FORT KNOX MINE

RECLAMATION AND CLOSURE PLAN

AMENDMENT 1

REVISION 1

Figure 2-1: 2020 Reclamation Activity

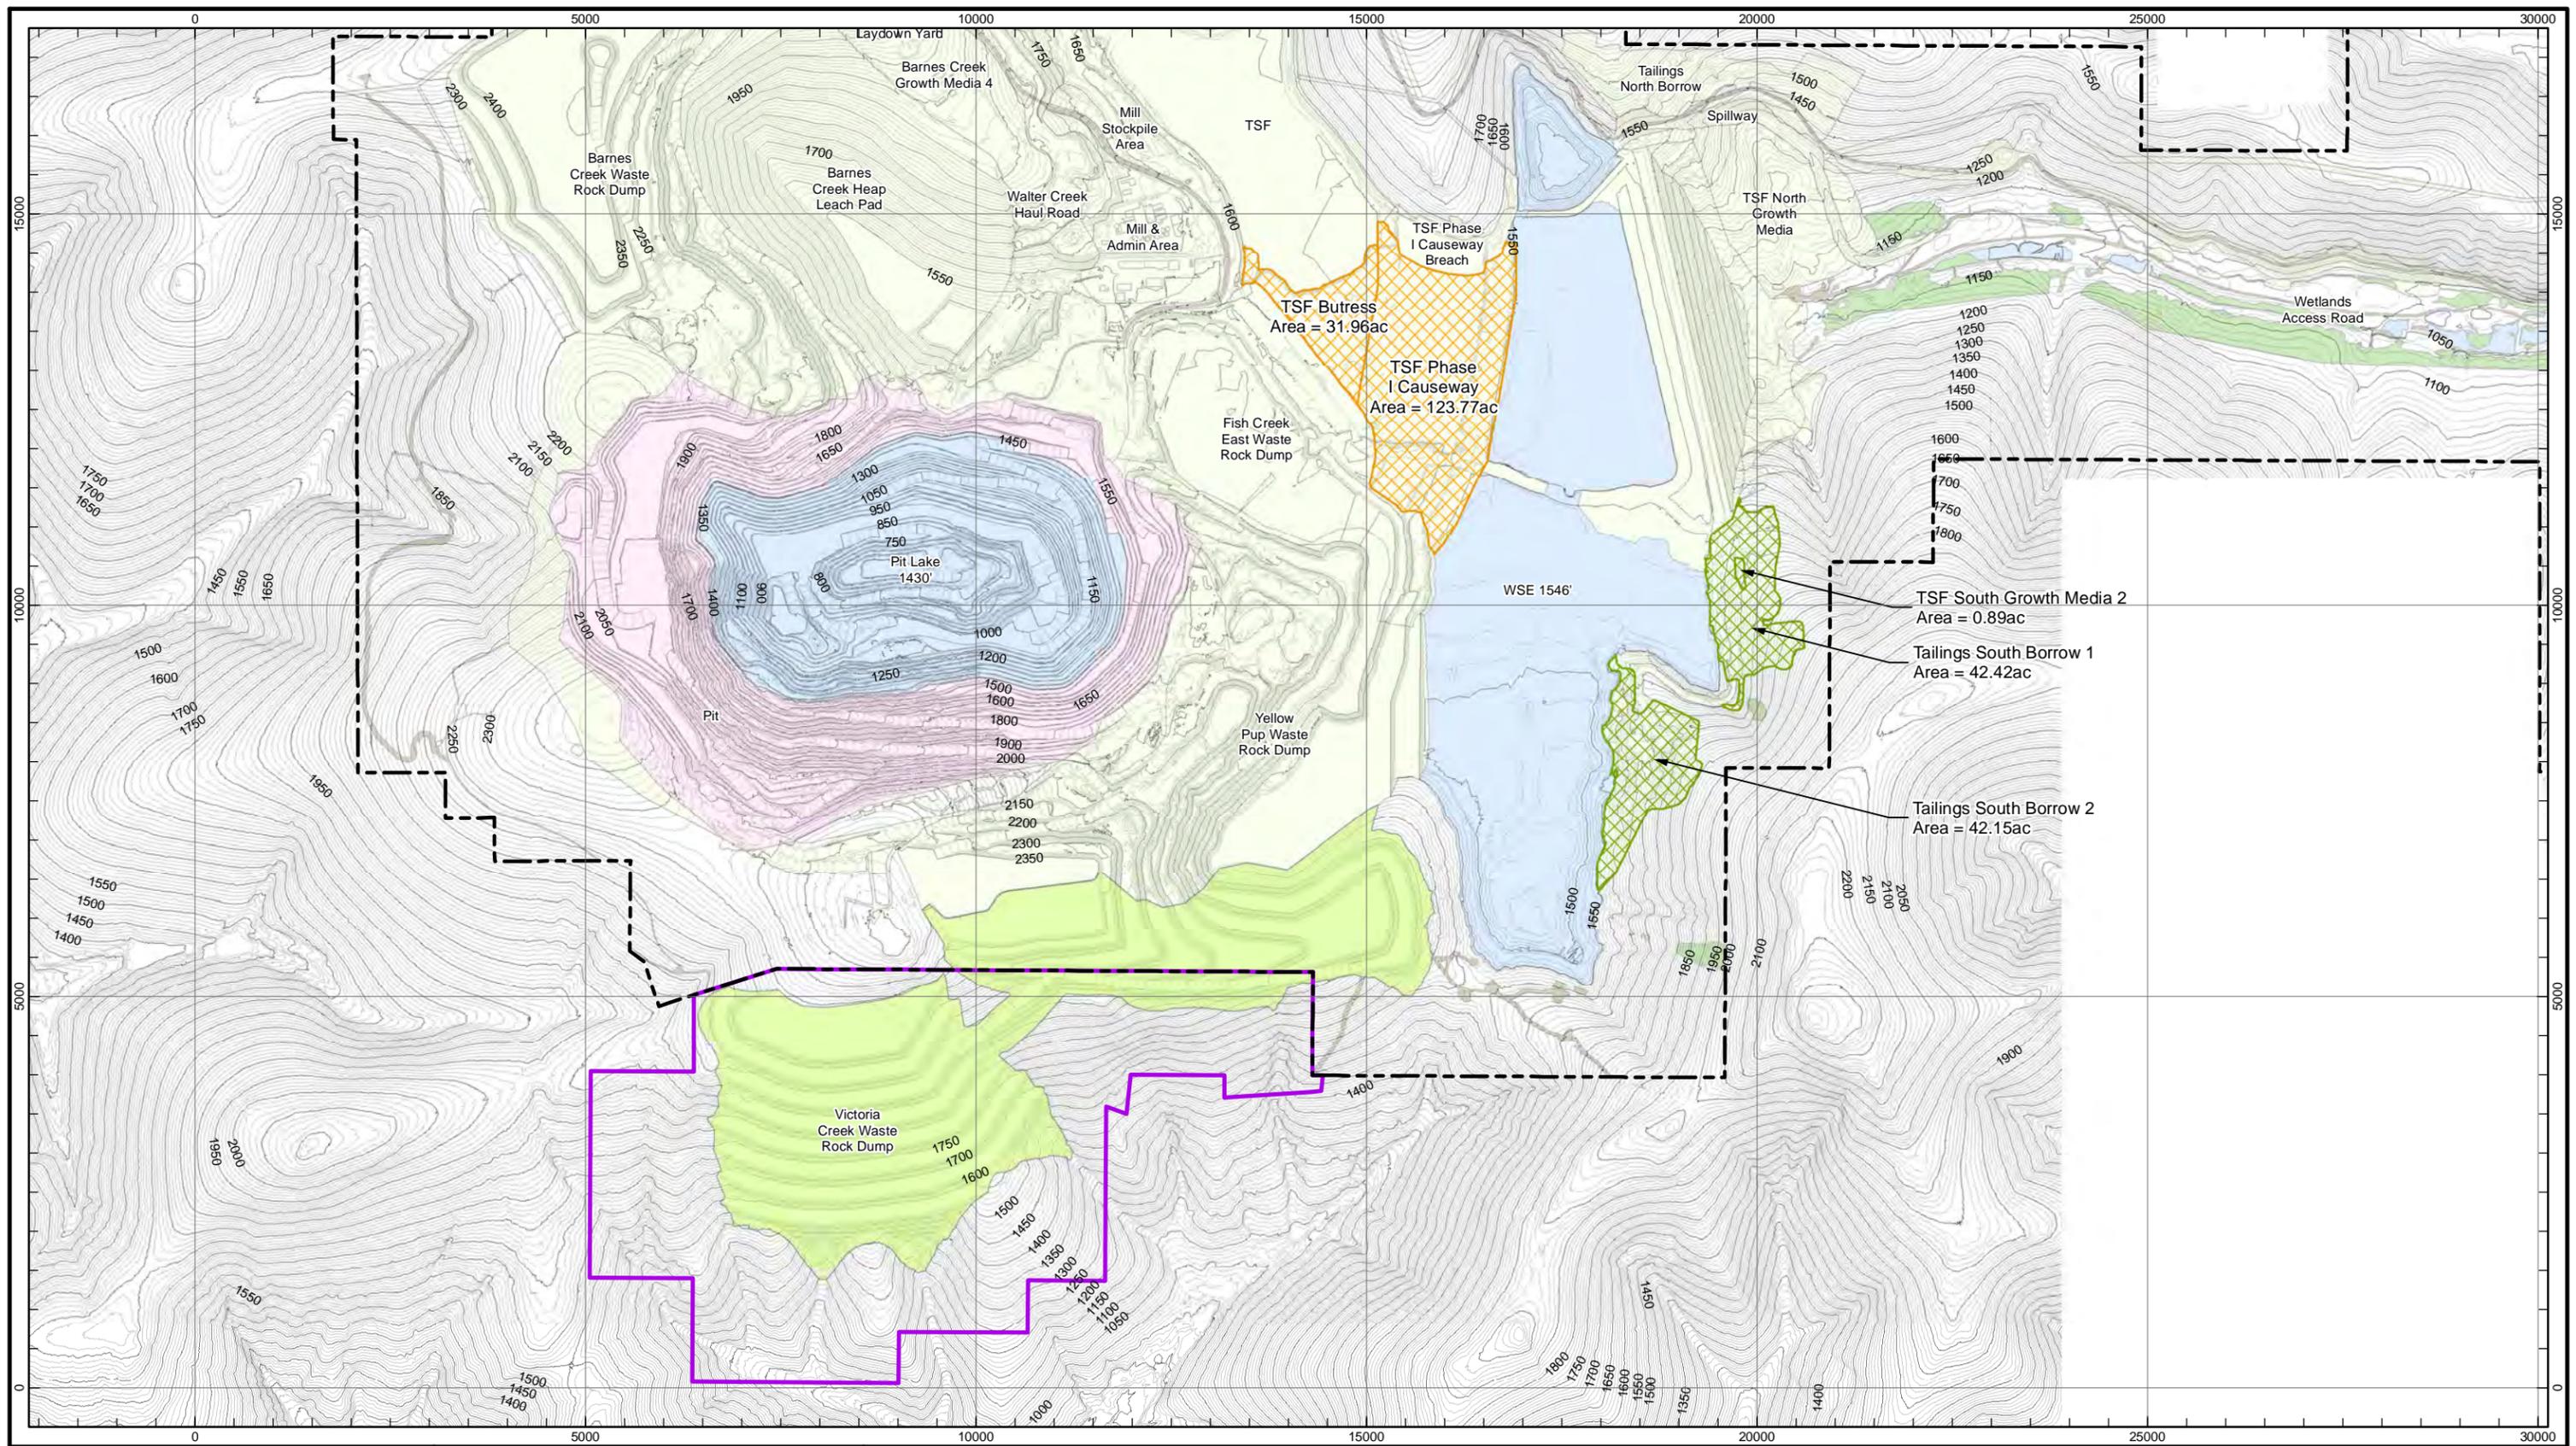
TSF South Borrow Site 1 and TSF Borrow Site 2 were reclaimed in 2020 equaling a total of 84.6 acres. The areas were regraded and covered with growth media sourced from the stockpile within TSF Borrow Site 1 (0.9 acres). The borrow sites were scarified and seeded. **Figure 2-1** illustrates the reclamation activity completed in 2020. The total reclaimed area completed in 2020 is approximately 85.5 acres

Figure 2-2: Victoria Creek WRD Post Mining Topography

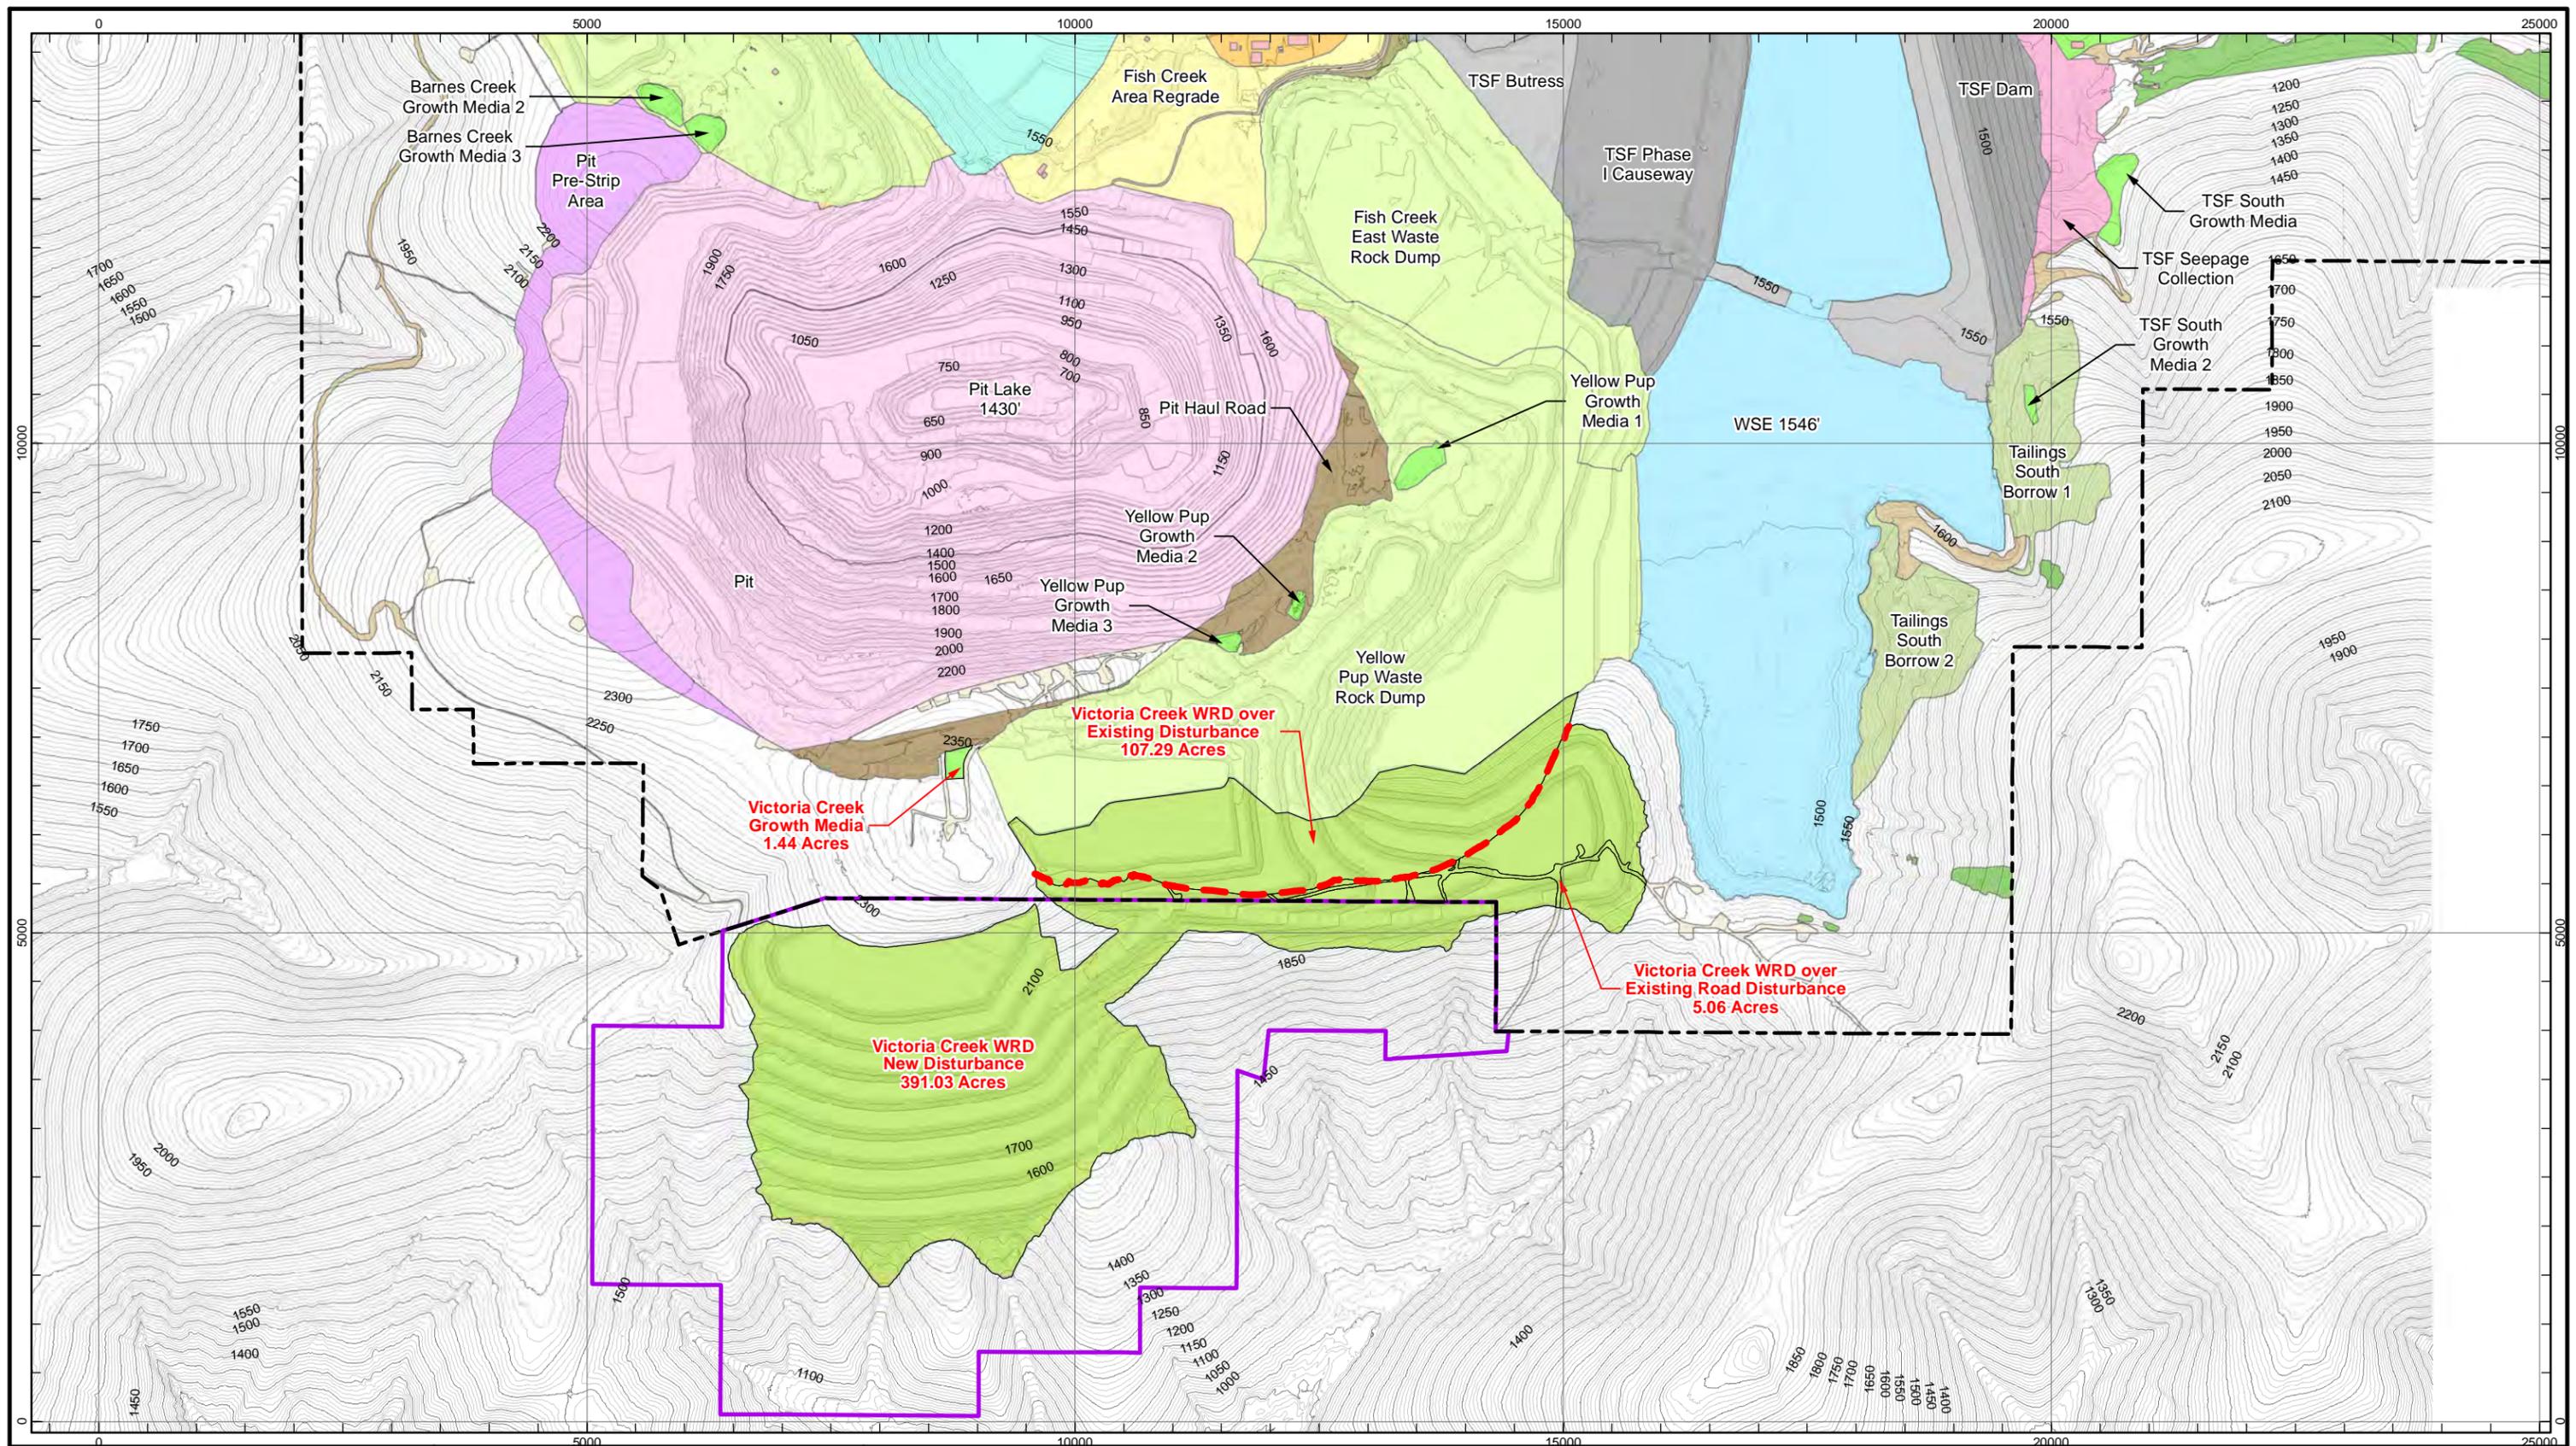
The construction of the Victoria Creek WRD will be similar to existing WRDs on site. The construction generally involves stripping and stockpiling suitable growth media (assume 12 inches), preparing a stable foundation for dump construction and end dumping waste rock in a benched configuration from the bottom, up. The benches are developed to allow for a regraded slope at closure mimicking slopes found near the project. Victoria Creek WRD development includes placement of approximately 85 Mtons of waste rock with capacity of up to 106 Mtons. The dump is constructed on approximately 498.3 acres of previously disturbed and undisturbed ground. Approximately 107.3 acres will be within the existing Yellow Pup WRD footprint and 391.0 acres will be on undisturbed ground. **Figure 2-2** depicts the proposed configuration of the Victoria Creek WRD.

The two-dimensional area listed in **Error! Not a valid bookmark self-reference.** include disturbances within the FGMI Millsite Lease boundary on state and private lands over the life-of-the mine at Fort Knox Mine. The construction of the Victoria Creek WRD will increase the disturbance by approximately 392.7 However; reclamation of the TSF borrow areas and GM stockpile and integration of the access road area within the Victoria Creek WRD’s area, results in a net disturbance increase of approximately 302.1 acres. Growth media stripped for the construction of the Victoria Creek WRD will be stockpiled near the rim of the pit adding approximately 1.4 acres of disturbance. **Figure 2-2** illustrates the corresponding disturbance area changes.
